UNION TOWNSHIP

BOARD OF TRUSTEES | DECEMBER 9TH, 2025 MEETING

ZONE MAP AMENDMENT & CONCEPT PLAN

STAFF REPORT: Case # 3-25-Z

SITE PLAN

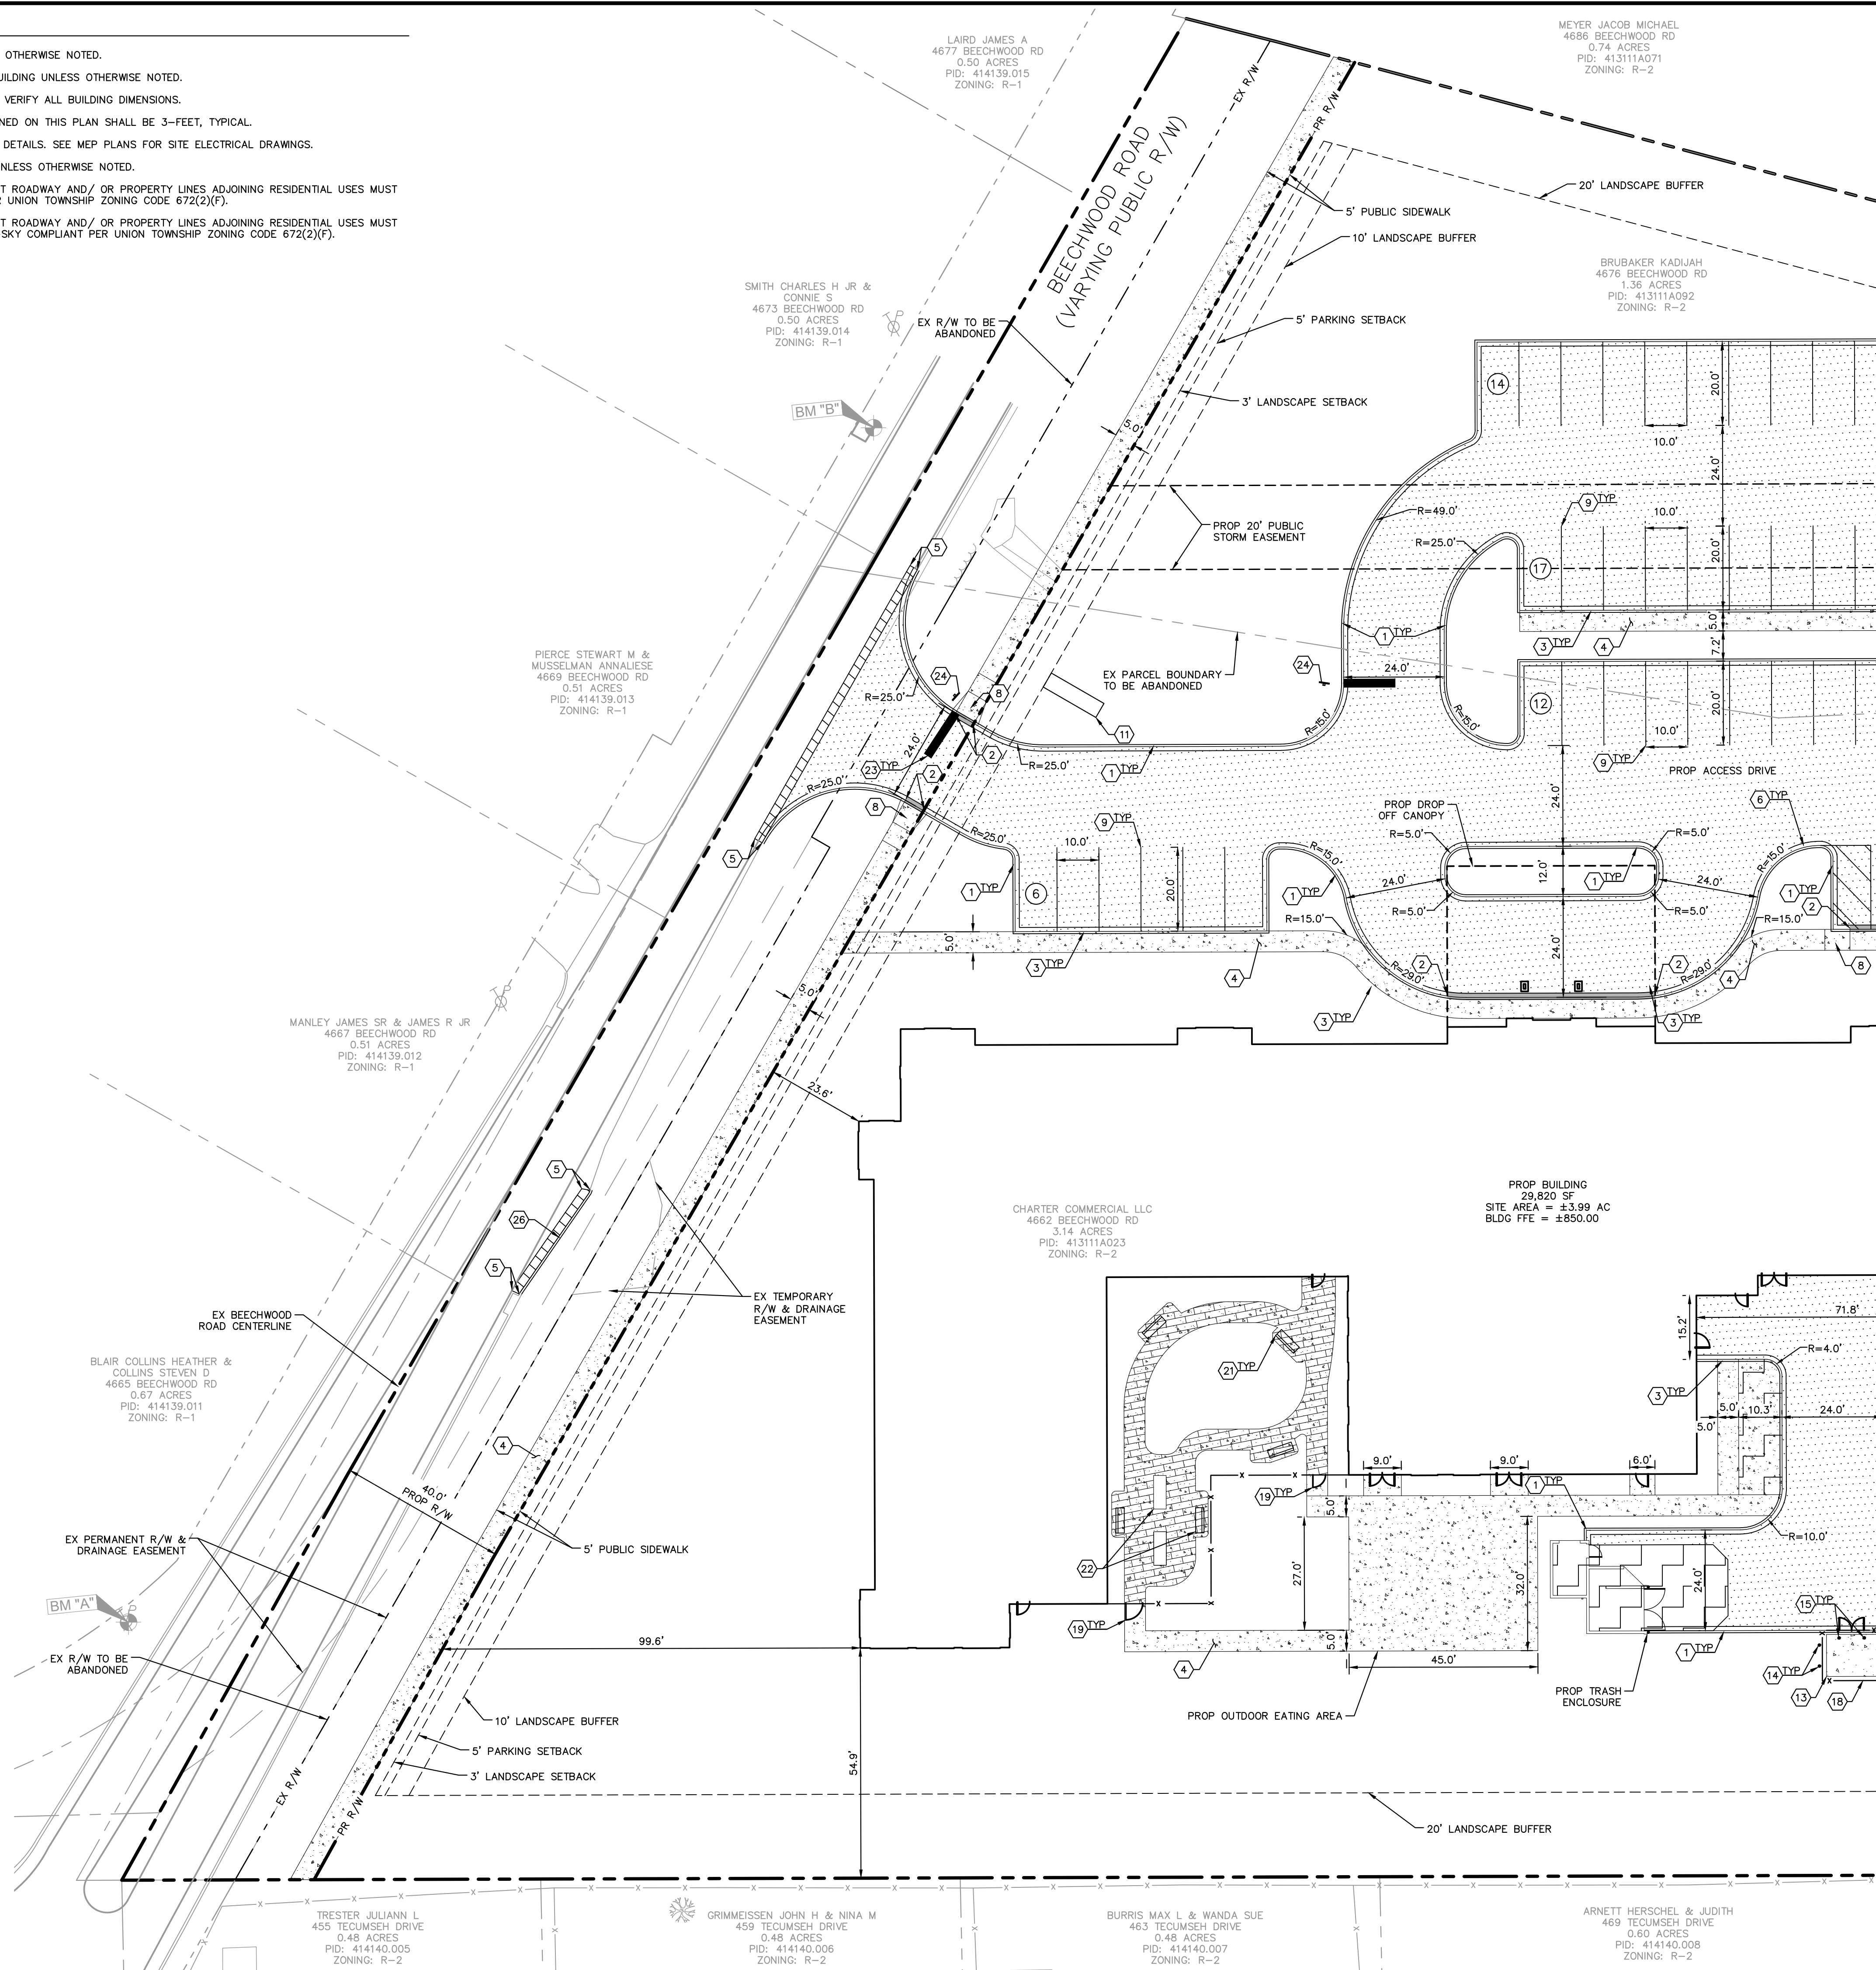
- 2) Staff recommends that existing vegetation be preserved along the southern and eastern property lines, to the extent possible. Additionally, staff recommends a berm along Beechwood Road—particularly between the proposed building and the road (and adjacent, existing residential uses).

- 3) The Applicant may need to remove or relocate the six (6) parking spaces located to the west, in close-proximity to the access point, off of Beechwood Road—particularly if Beechwood Road needs to be widened in the future or if deceleration lanes or a turn lane becomes necessary.
